6100/6150 SDI-12 Interface Cable

The 6100/6150 SDI-12 Interface Cable has been developed to implement some extra features for the 6100 and 6150 water level monitors. This new cable is designed to be a direct replacement for the existing cable. All connections remain the same.

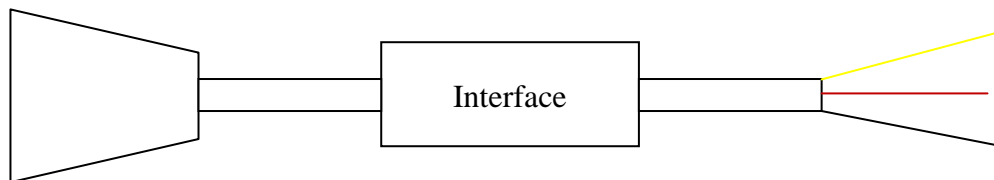
The cable is connected between the 6100 or 6150 in exactly the same way as a standard cable.

Once the SDI-12 Interface Cable is installed, the 6100/6150 will now respond with a CRC when requested. This applies to the following commands:

The 6100/6150 will also correctly send two 'n' characters in response to a concurrent measurement request. This applies to the following commands:
